AMA Designer's Response

Proposed Residential Development – Westgate, Cleckheaton

21st March 2022

Road Safety Audit: Stage 1-S278 and S38

Appendix C – Swept Path Analysis

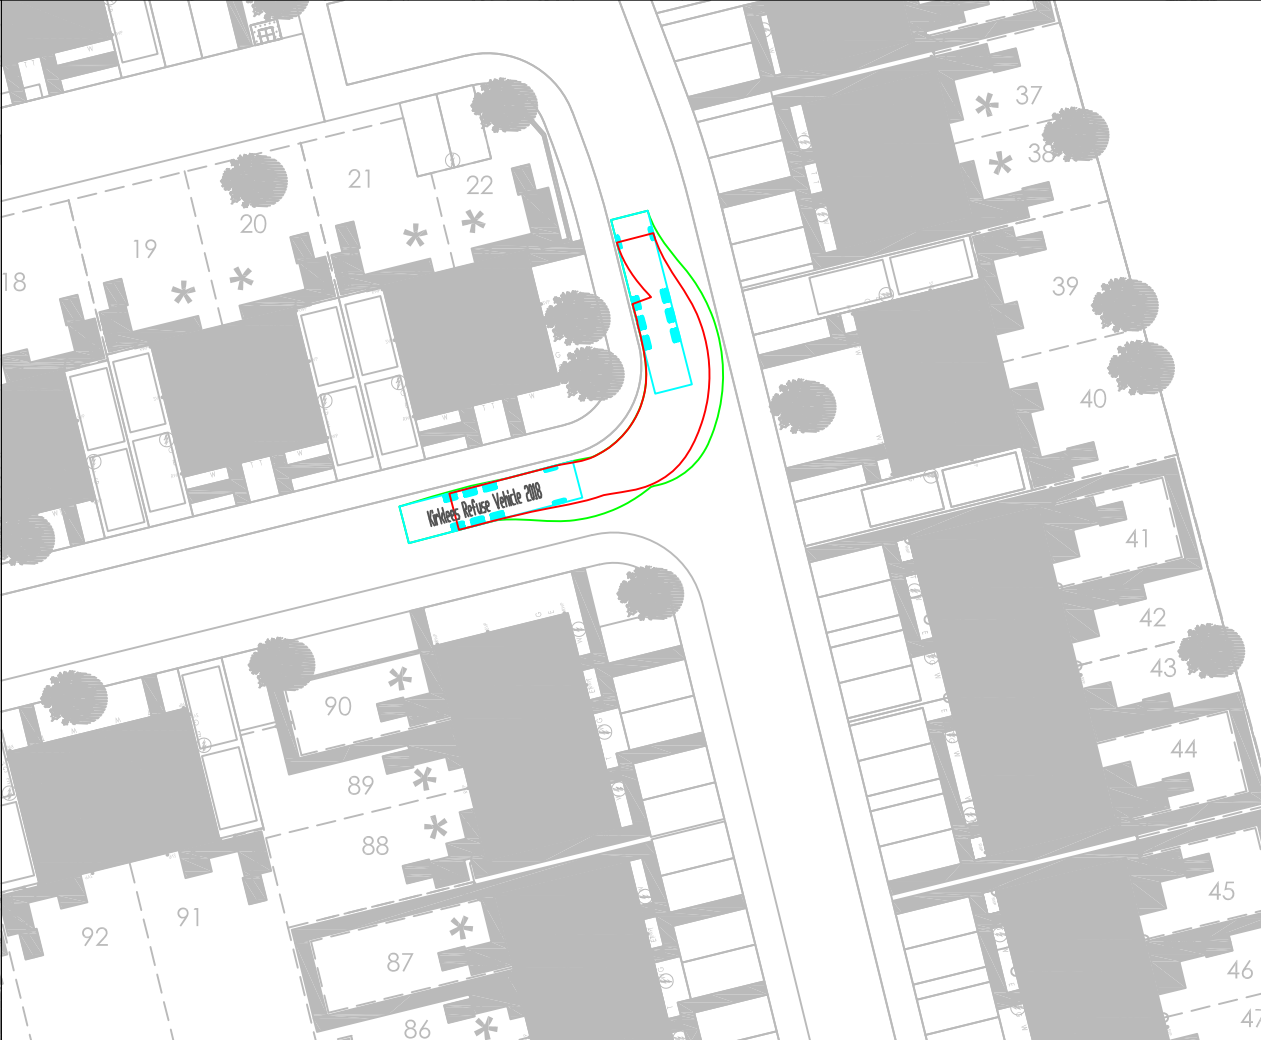
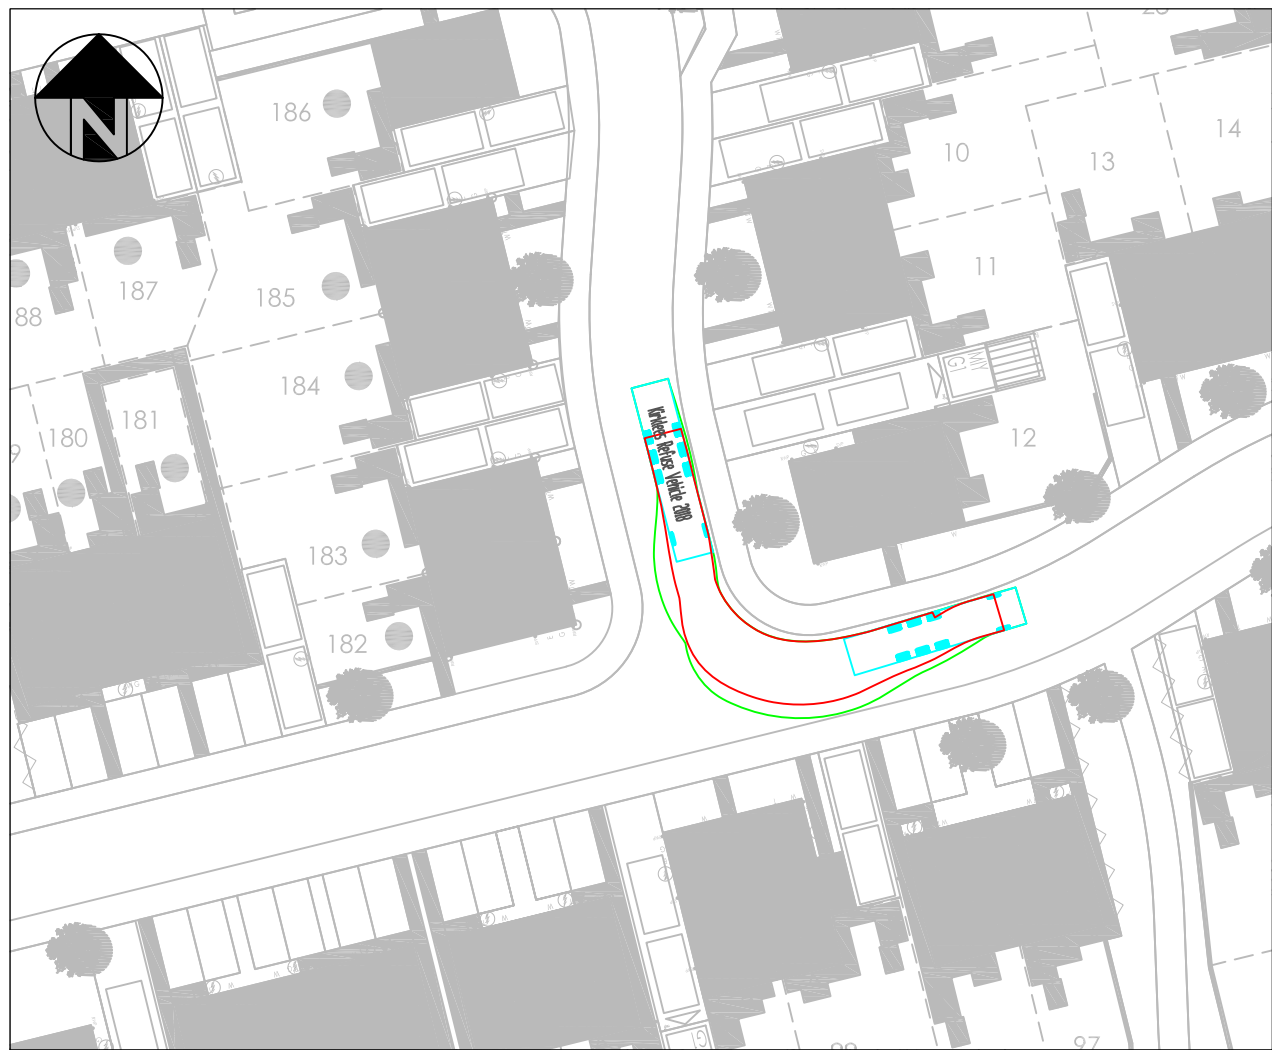
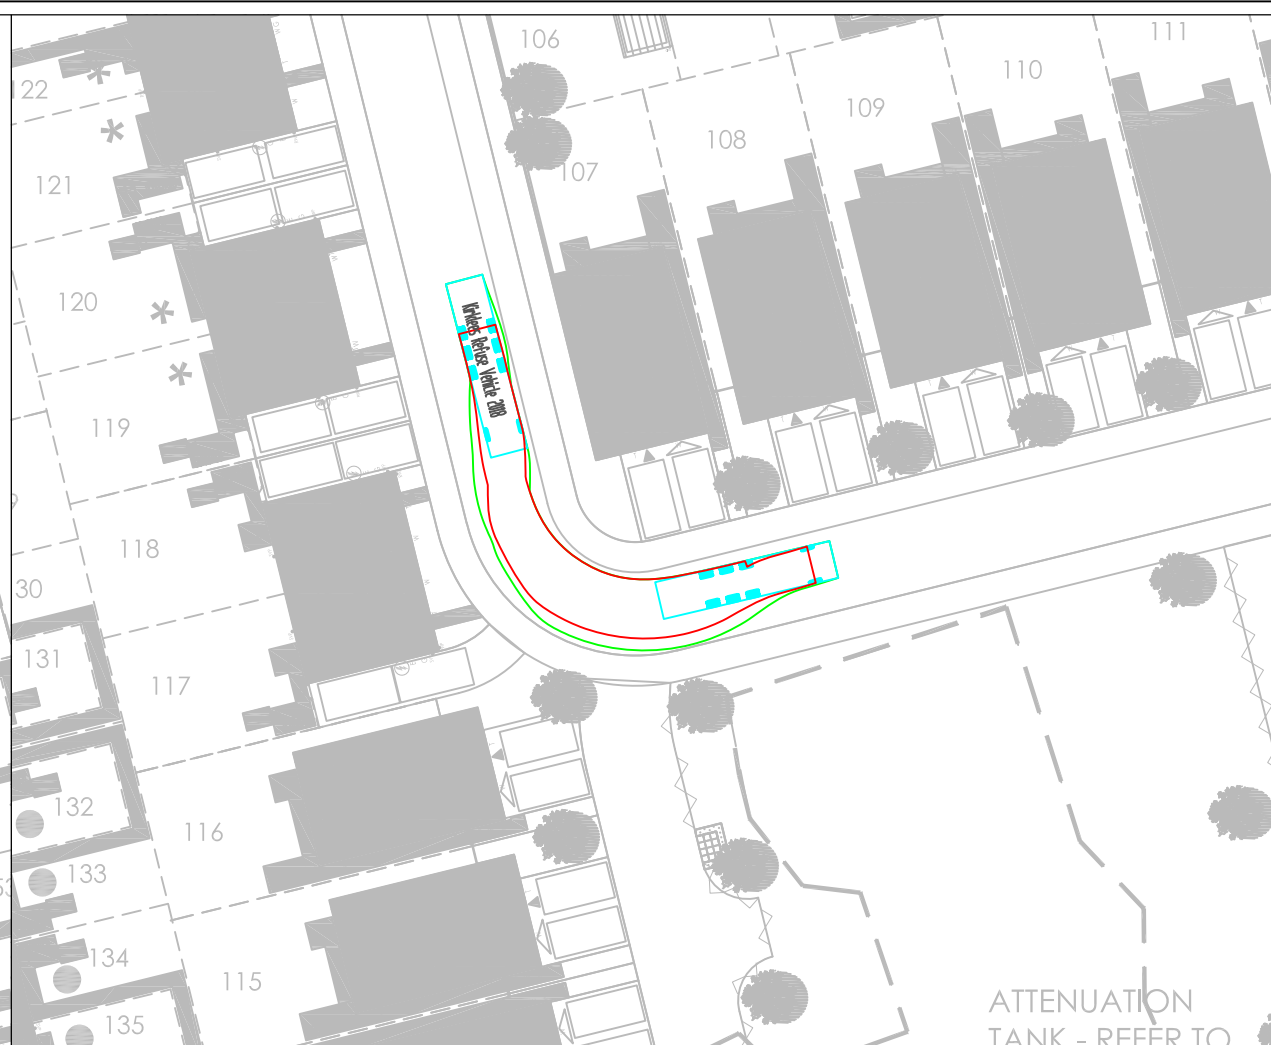
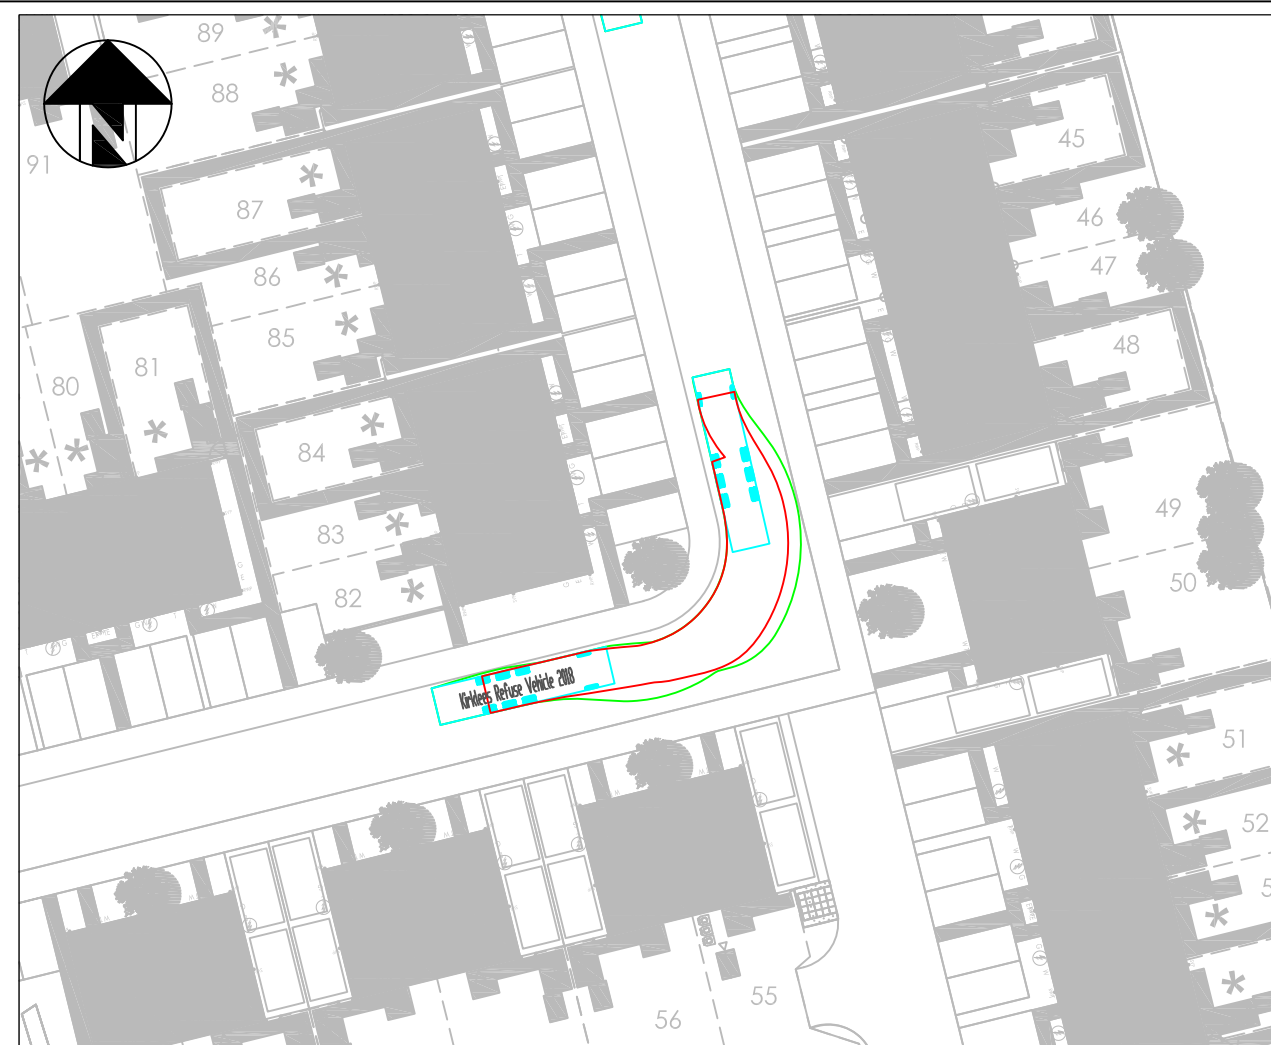
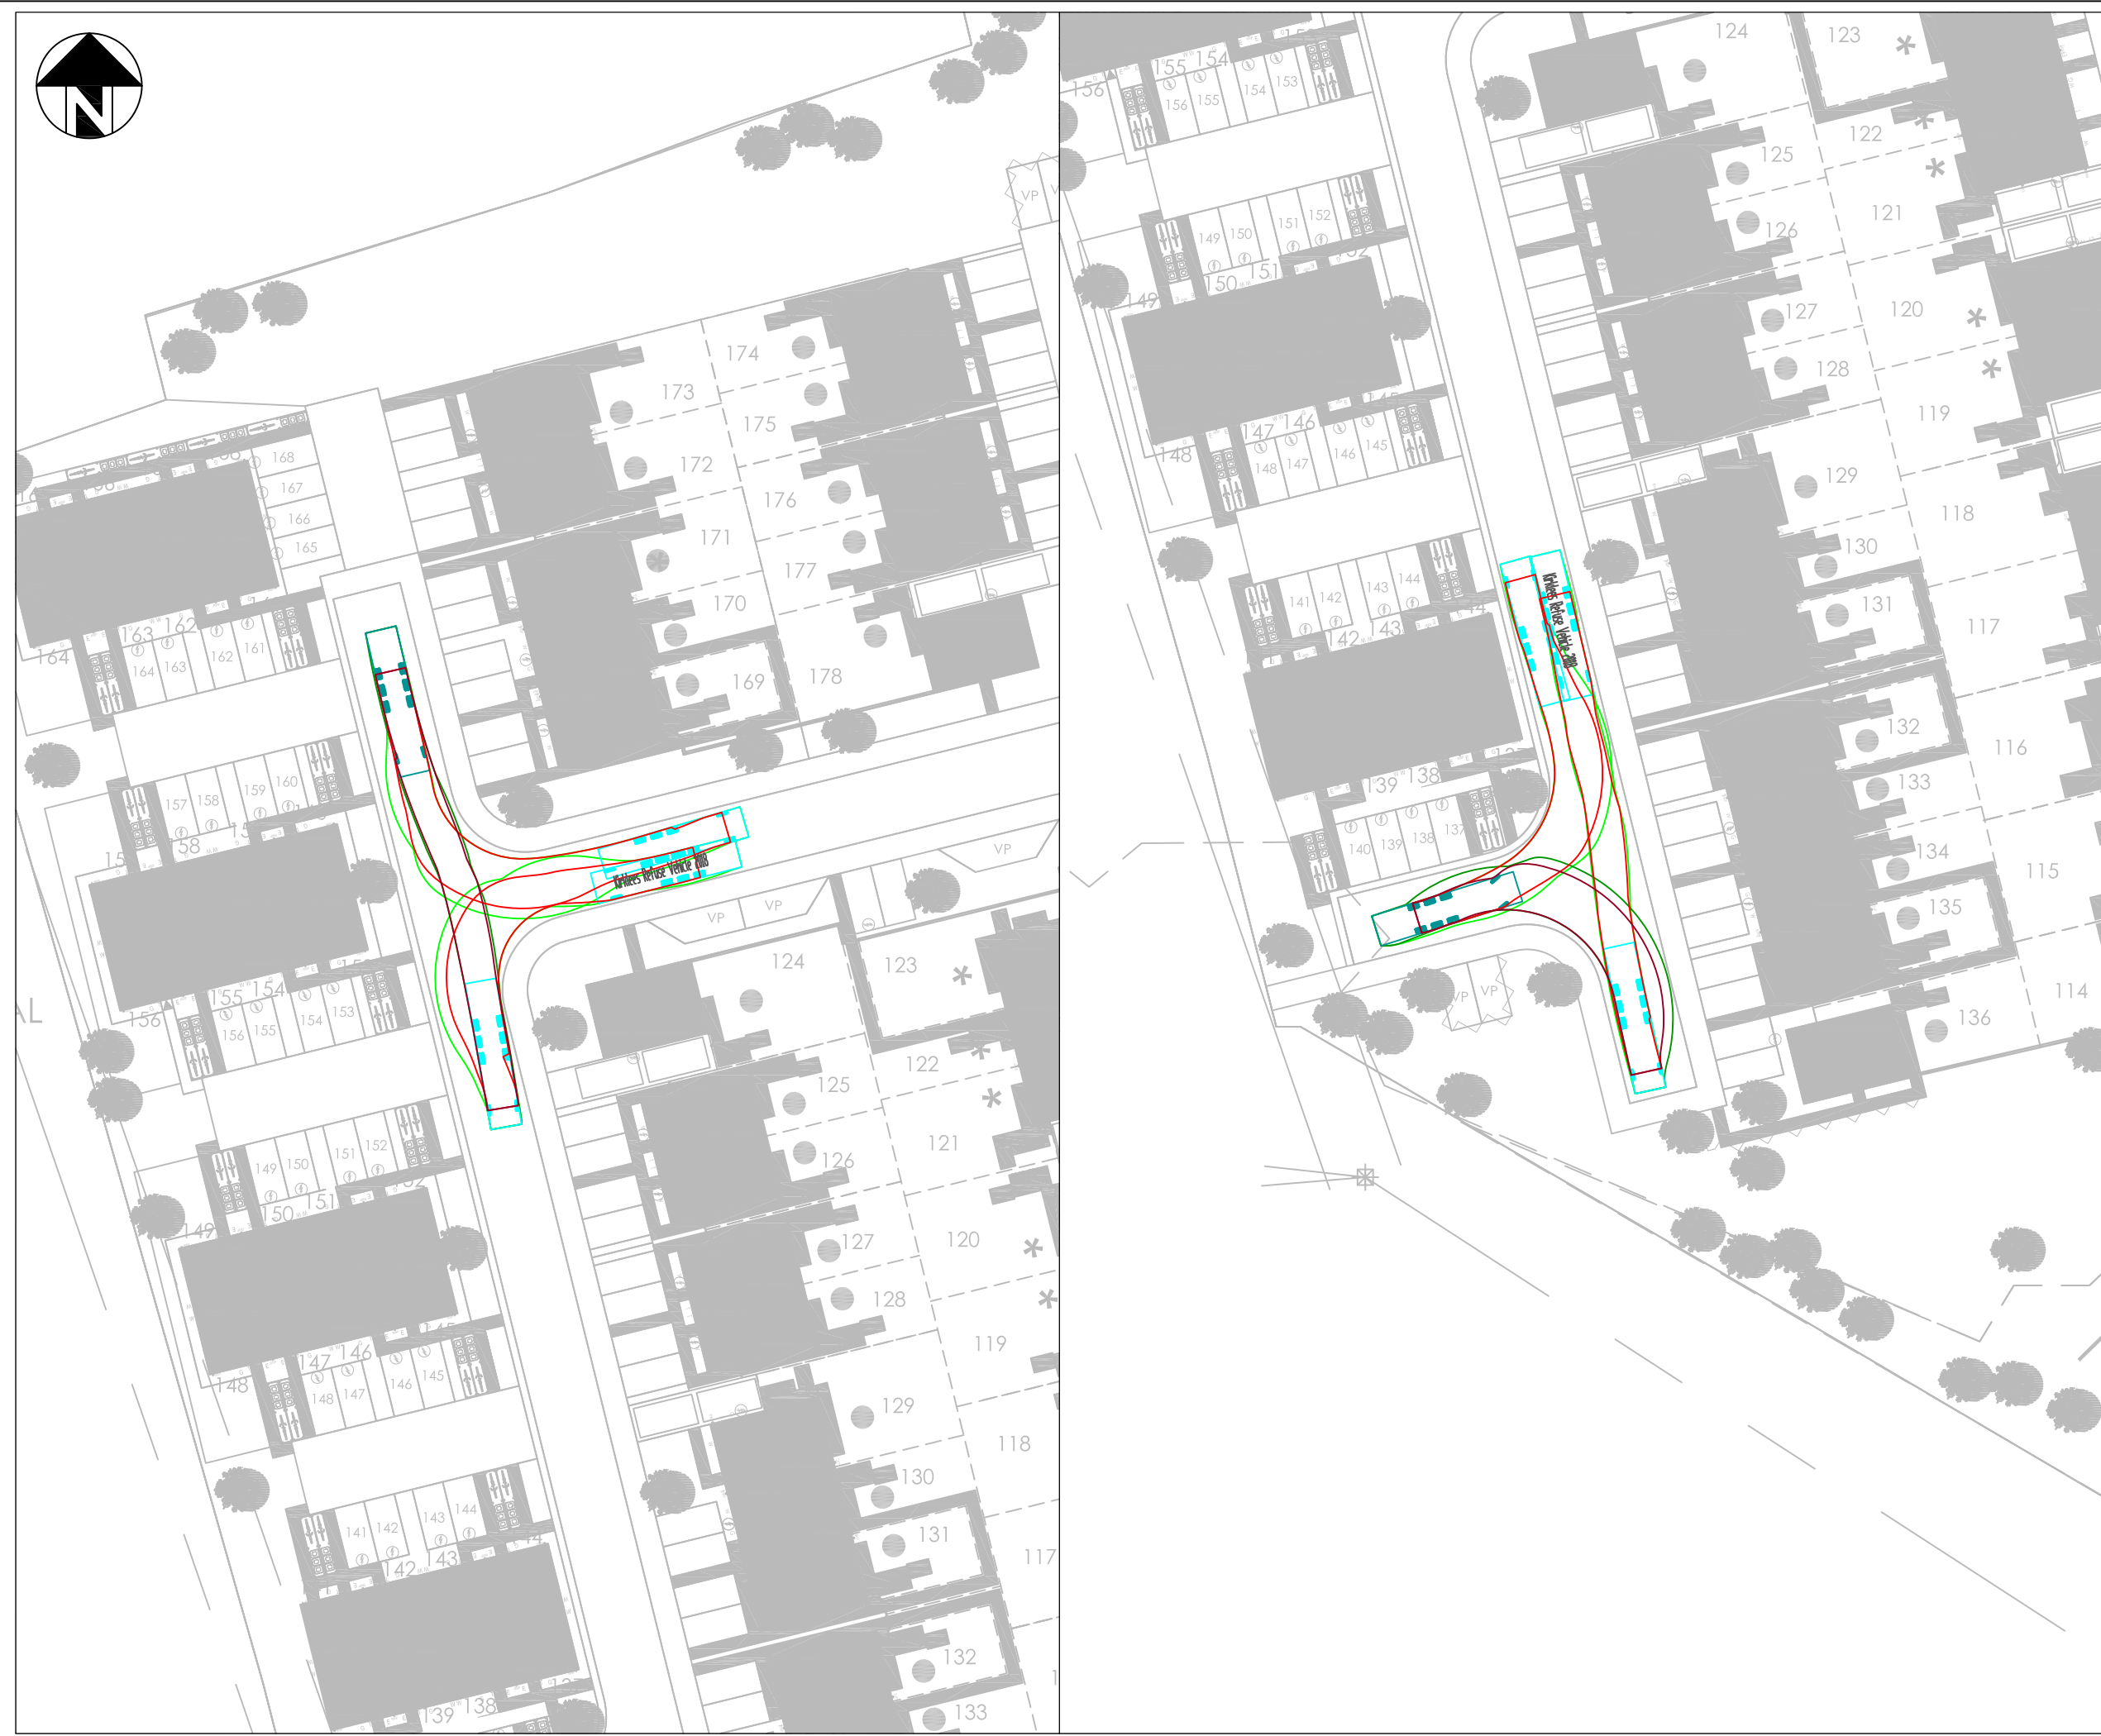
Details of vehicle tracked movements are not provided on the drawings. Inappropriate carriageway widths and turning radii can result in increased vehicle collisions as well as pedestrian-vehicle collisions.

Summary: *Details of the swept paths of vehicles, are not provided on the drawings. Inappropriate carriageway widths and junction radii can result in vehicles failing to safely negotiate the new junction arrangements.*

Provide swept path movements at all locations where the junction layouts will be changed, and new junctions created.

Swept Path Analysis of a 'Kirklees Refuse Vehicle 2018' has been tracked around the proposed access and internal layout to ensure that the road layout is safe and functional. Details of the swept path analysis is provided in **Appendix C** to this Designers Response.
